LOT GRADING REVIEW

LECCO RIDGE DEVELOPMENTS INC.

LOT No. 229

PART OF LOT 6 CONCESSION 2, NEW SURVEY
(GEOGRAPHIC TOWNSHIP OF TRAFALGAR)
REGIONAL MUNICIPALITY OF HALTON
20M-1184 TOWN OF MILTON

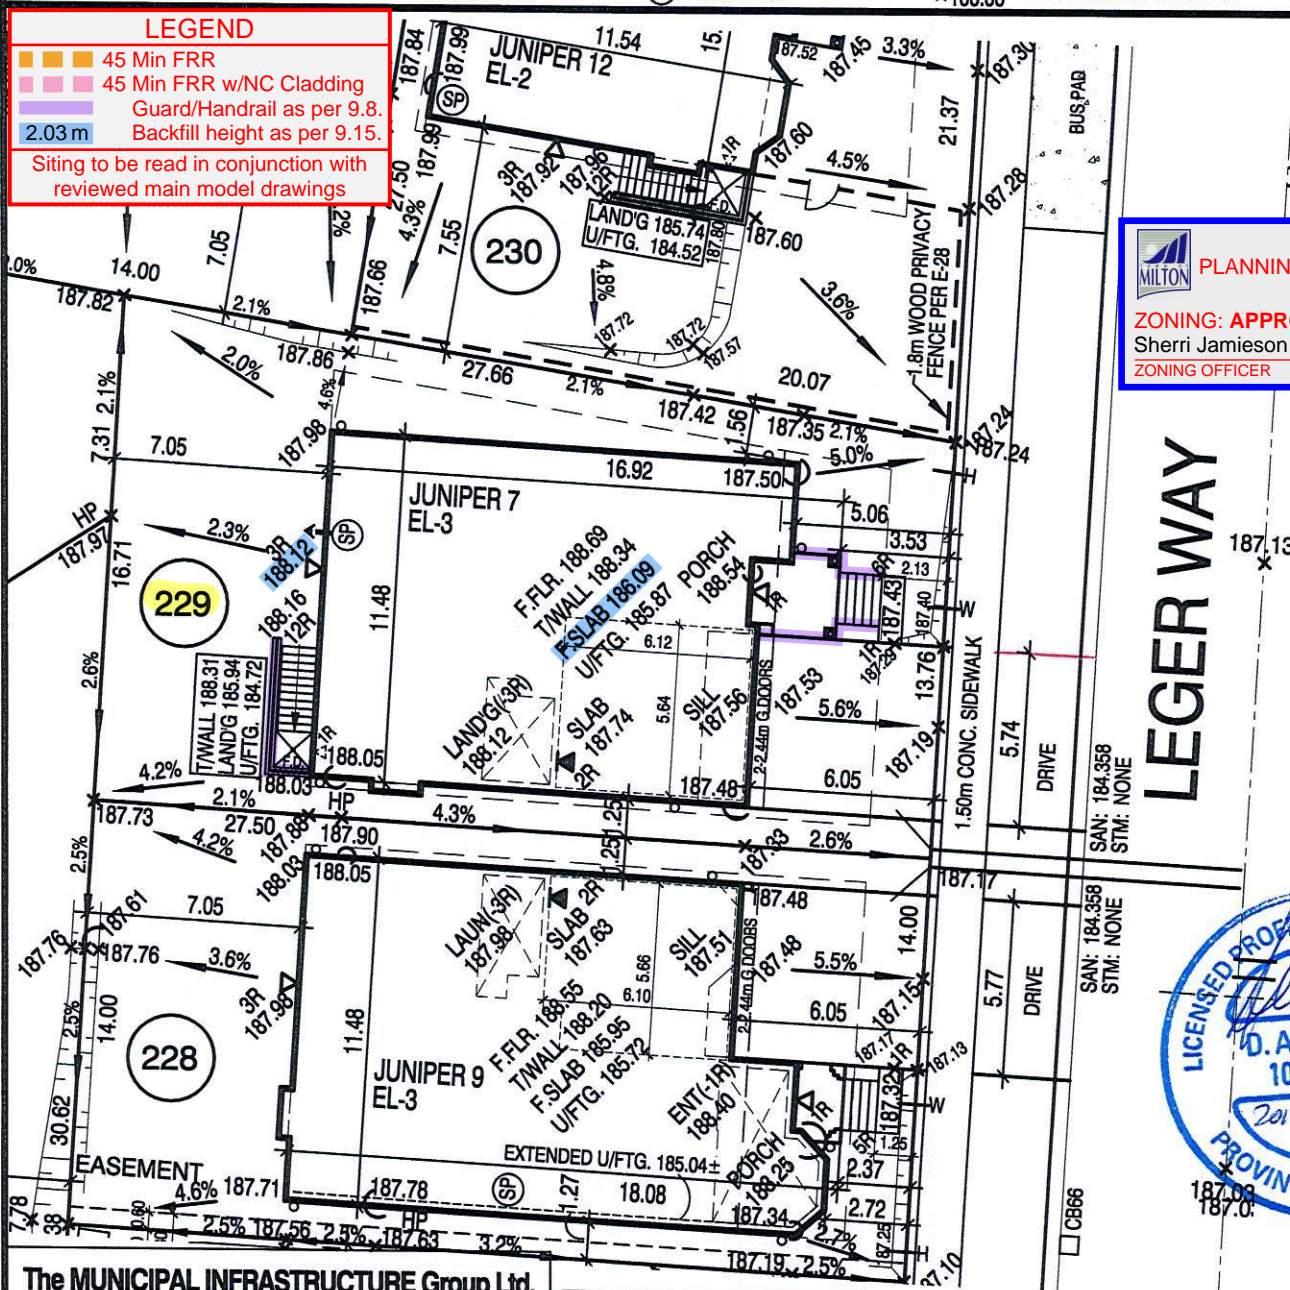
45 Min FRR
45 Min FRR w/NC Cladding
Guard/Handrail as per 9.8.
Backfill height as per 9.15.

Siting to be read in conjunction with reviewed main model drawings
